Subject: Engineering, Procurement and Construction (EPC) Contract for Renovation and Modernization of Existing Navigational Lock at Farakka, West Bengal.

Reference: IN-IWAI-350002-CW-RFB-2

Amendment-5

Amendment triggered due to pre-bid responses:

JOB. NO.	DRG. NO.
	ENL013

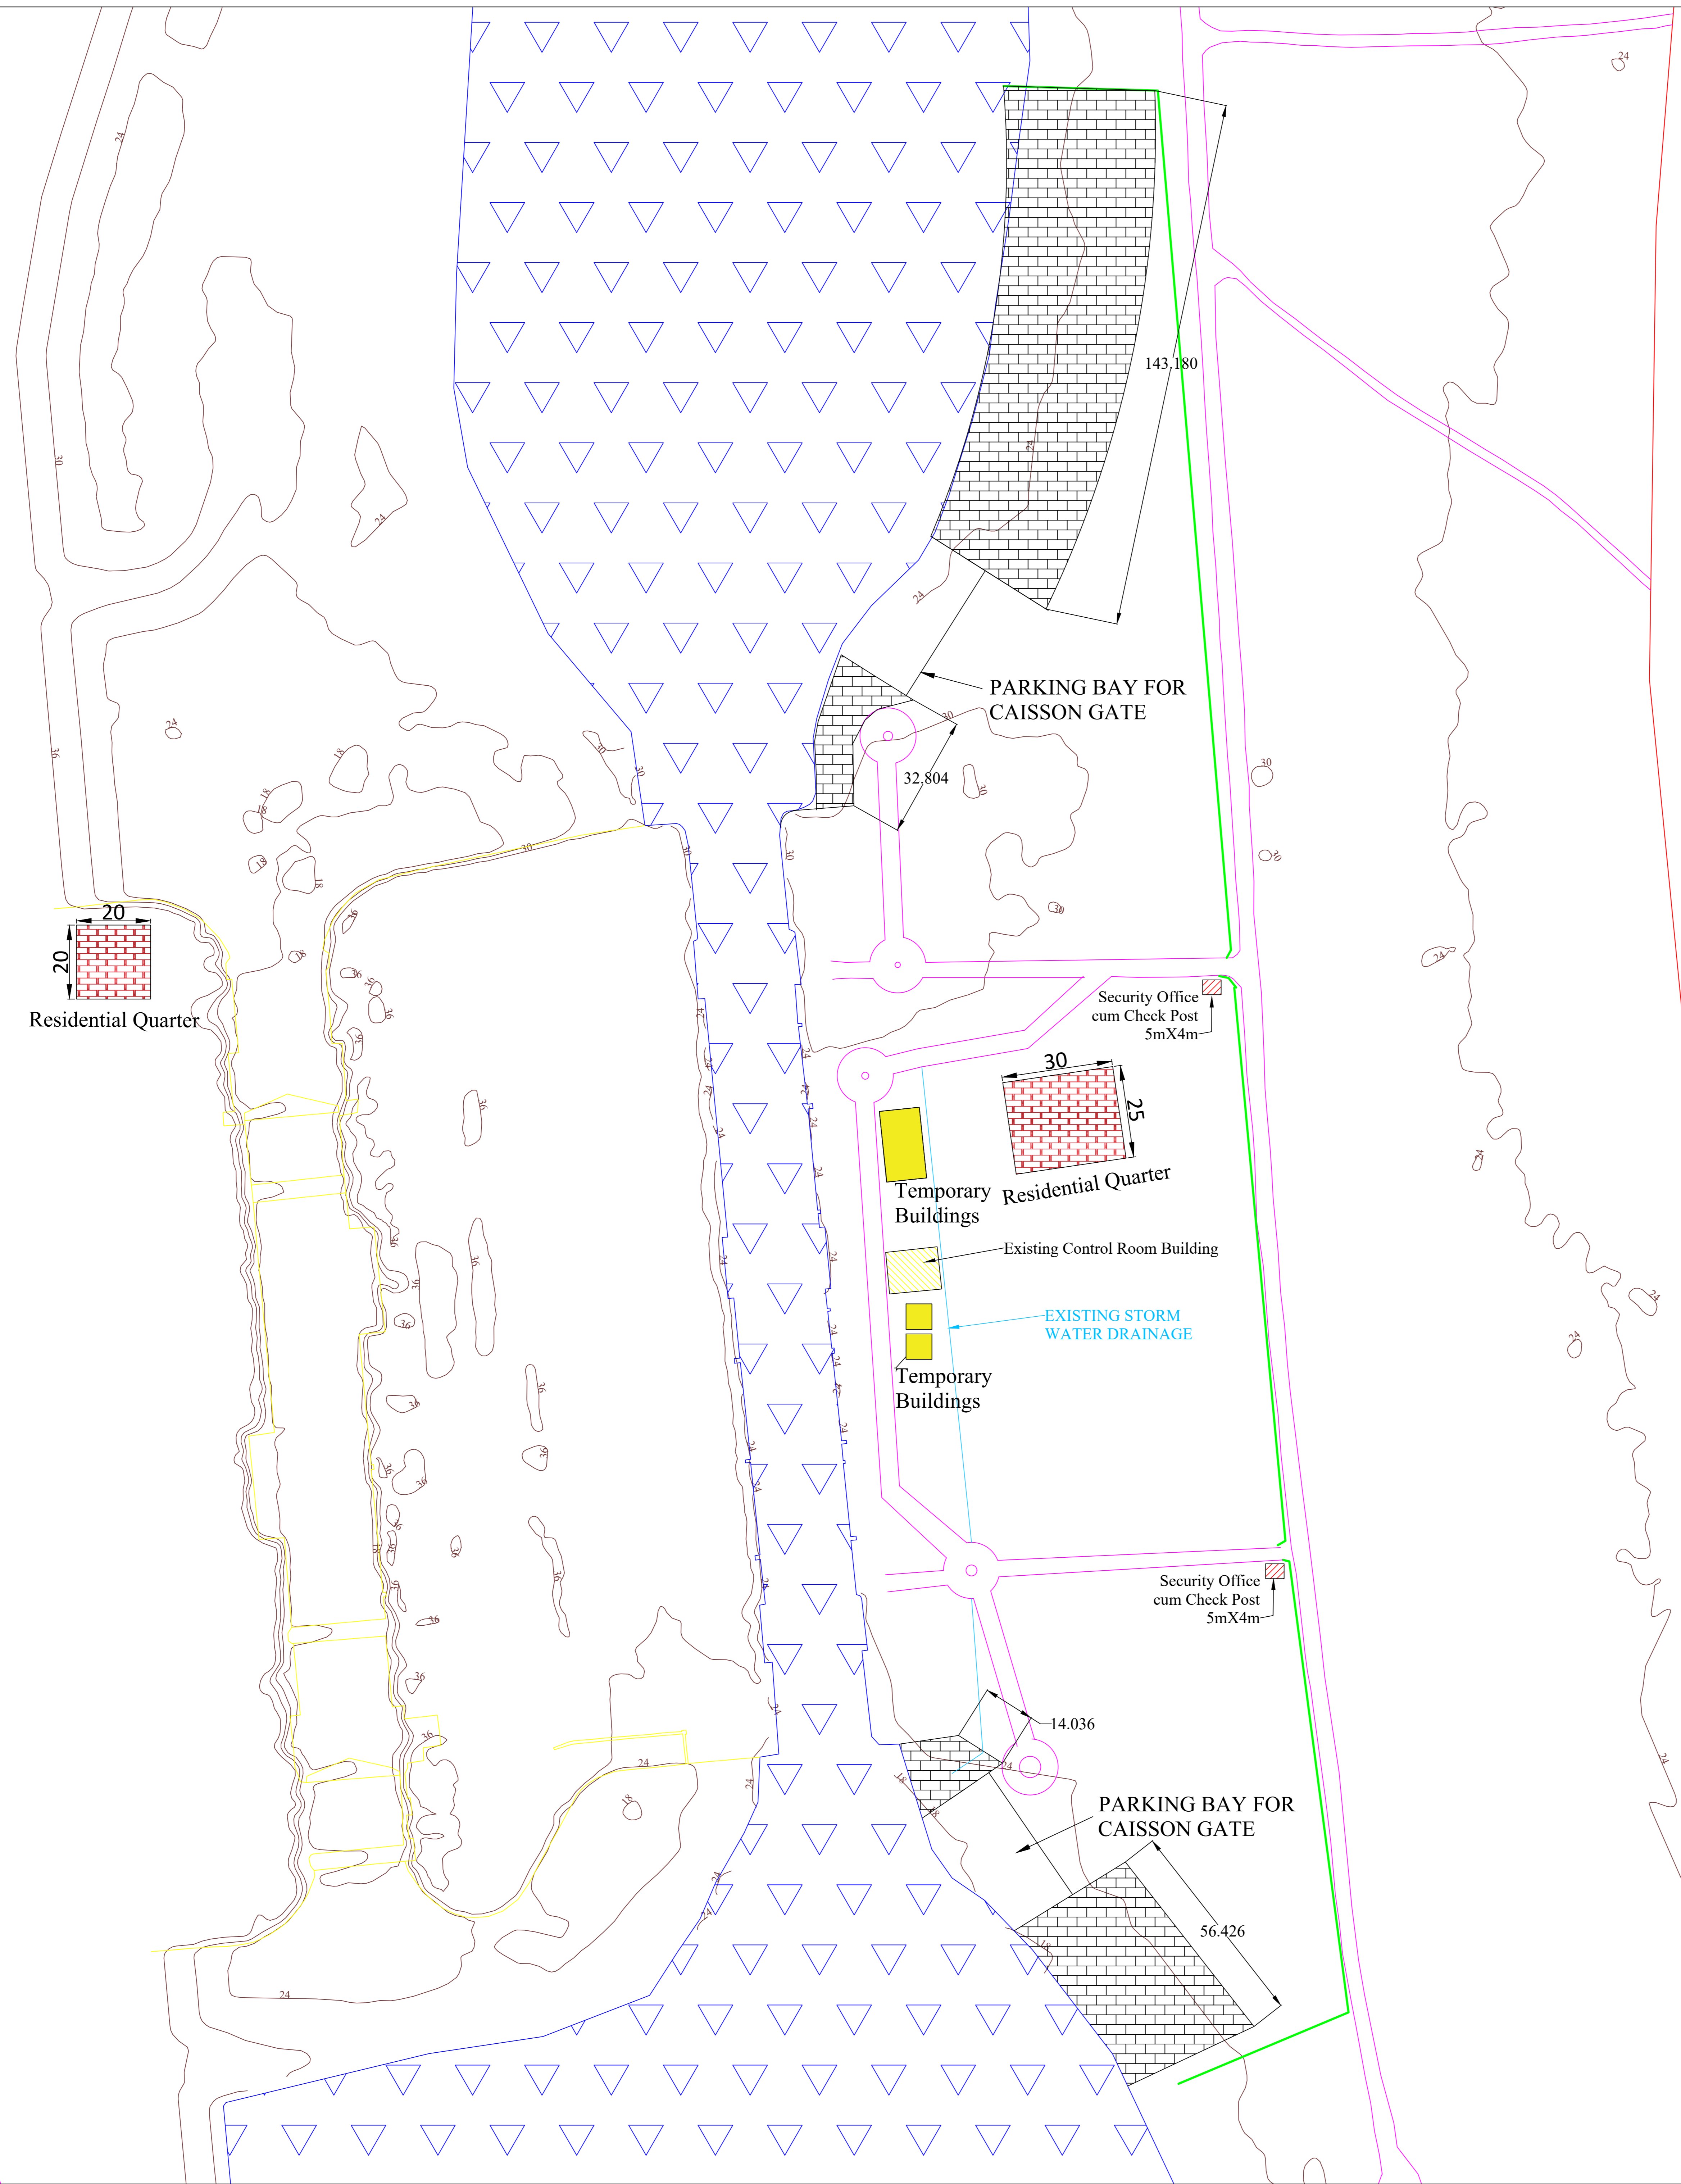
24	Residential Buildings, Vol II, 1.2.5.2, Page No- 29	Location of the proposed quarters are shown in Drawing No. ENL 013	Please refer drawing number ENL 013_R1 attached at Annexure-A.
25	Synchronized Operation of Existing and New Navigational Lock through Integrated Signal System, Vol II, 1.2.16, Page no- 41	The movement of traffic through both the navigational locks (Existing & New) shall be managed from an integrated signal system. The integrated signal system should be installed at the upstream and downstream of the lock for synchronized operation through both the locks (Existing & New) resulting in safe and reliable and smooth movement of vessels. The integrated signal system should be interoperable from both the existing and new navigational lock control room . The Contractor shall do the design, installation, testing and commissioning of the integrated signal system for traffic management for synchronized operations of the movement of traffic through the Existing and New Navigational lock as per specifications for Signal System covered under Section 4.25.	Clause no 1.2.16 at Page no- 41, Vol-2 may be read as: The movement of traffic through both the navigational locks (Existing & New) shall be managed from an integrated signal & Hooter system. The integrated signal & Hooter system should be installed at the upstream and downstream of the lock for synchronized operation through both the locks (Existing & New) resulting in safe, reliable and smooth movement of vessels. The integrated signal system should be interoperable from both the existing and new navigational lock control room. The Contractor shall do the design, installation, testing and commissioning of the integrated signal & Hooter system for traffic management for synchronized operations of the movement of traffic through the Existing and New Navigational lock as per specifications for Signal System covered under Section 4.25. The Hooter system shall be duly synchronized with the opening & closing of the gates.

<p>General Pool Residential Accommodation (Type I to VI). Location of the proposed quarters are shown in Drawing No. ENL 013.</p>	<p>10.Exhaust Fans All other required amenities shall be provided as per the Revised Specifications & Scale of Amenities for General Pool Residential Accommodation (Type I to VI). Location of the proposed residential quarters are shown in Drawing No. ENL 013_R1 attached at Annexure-A.</p>
--	--	---	---

NATIONAL WATERWAY NO.-1
 RIVER GANGA
 POND CHANNEL FARAKKA
 SCALE - 1:5000

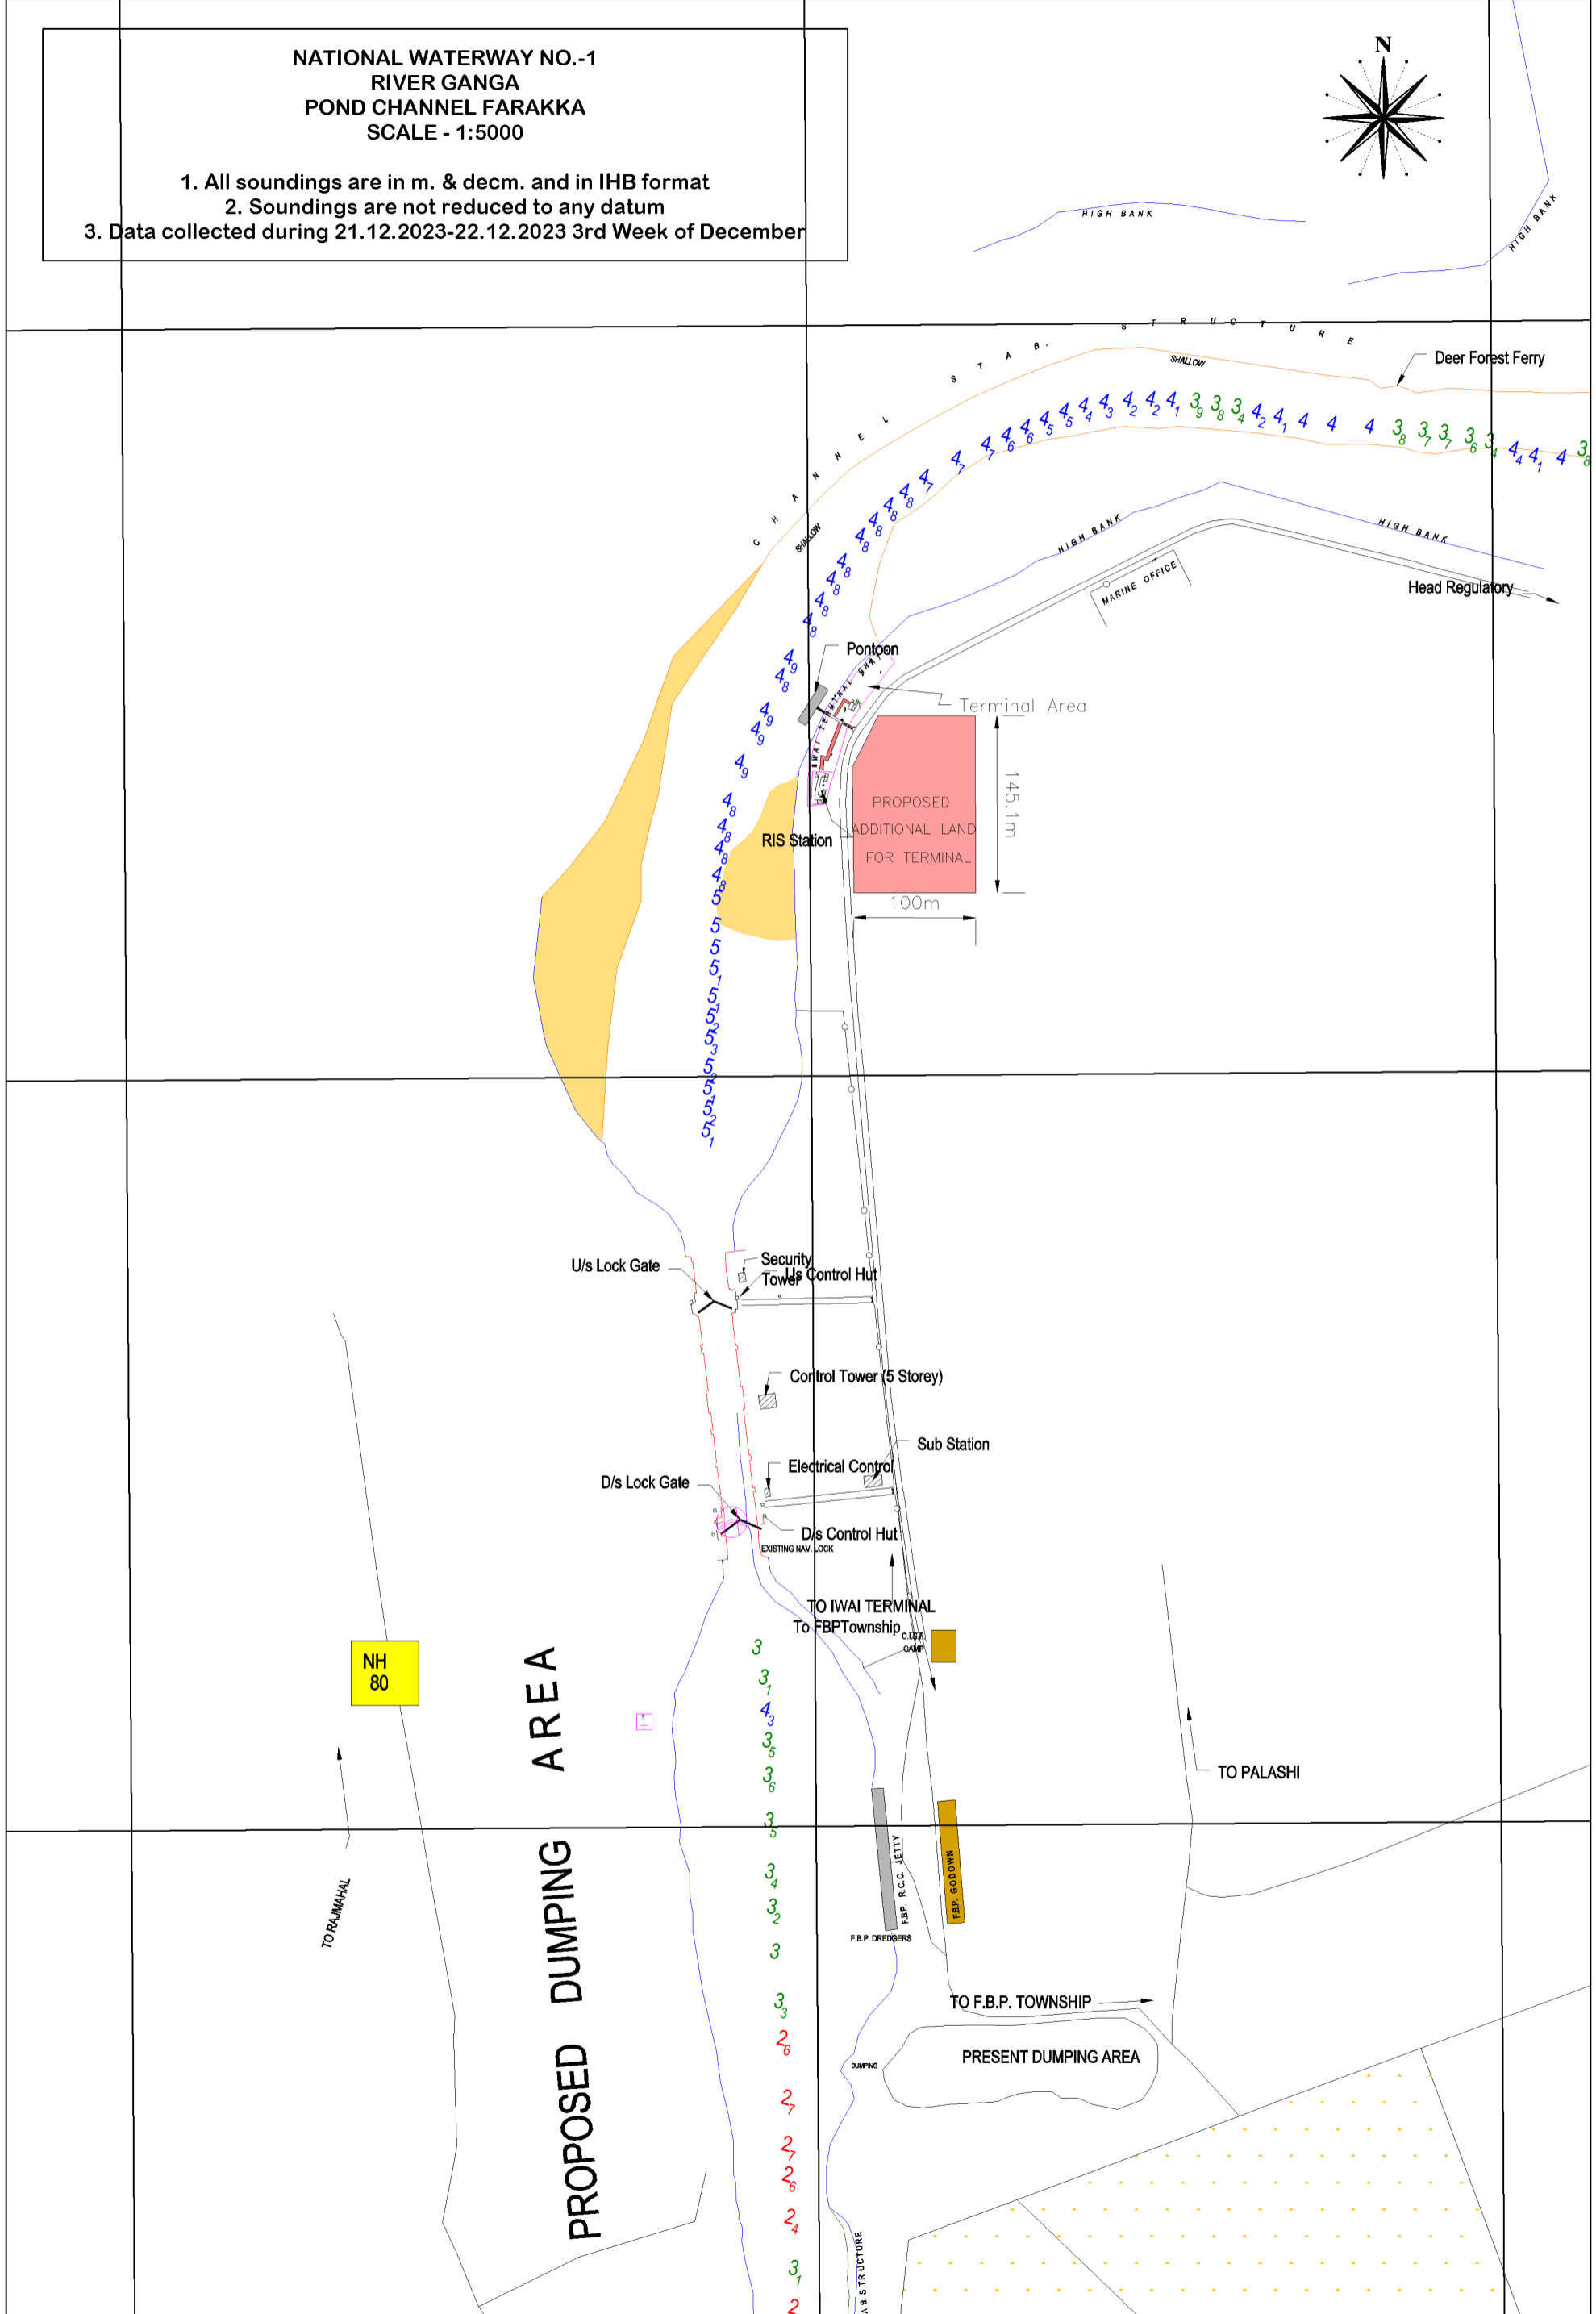
Sr. No	Description	As per Bidding documents		Amended
1	General-Bathymetry			The available Bathymetry Survey is attached as Annexure-B for reference. Bidder shall do their due diligence.
2	Vol - 1 Bid Documents, 2.2.5.(a), pg 50 of 346	The bidder should have ISO 14000 & OHSAS certification.		The clause 2.2.5.(a) at Page 50 of 346 of Vol - 1 Bid Documents may be read as: “The bidder should have ISO 14000 & ISO 45001 certification. ”.
3	Vol - 1 Bid Documents, 2.5, pg 55 of 346	Position	Qualifications	Clause no 2.5, at page no 55 of Vol-1 may be read as:
		Project Manager & Team Leader	B.E. / B. Tech (Civil Engg.)	
		Asst. Project Manager	B.E. / B. Tech (Mechanical Engg.)	
		Mechanical Engineer	B.E. / B. Tech (Mechanical Engg.)	
		Electrical Engineer	B.E. / B. Tech (Electrical Engg.)	
		Position	Qualifications	
		Project Manager & Team Leader	B.E. / B. Tech (Civil Engg.)	
		Asst. Project Manager	B.E. / B. Tech (Mechanical Engg.)
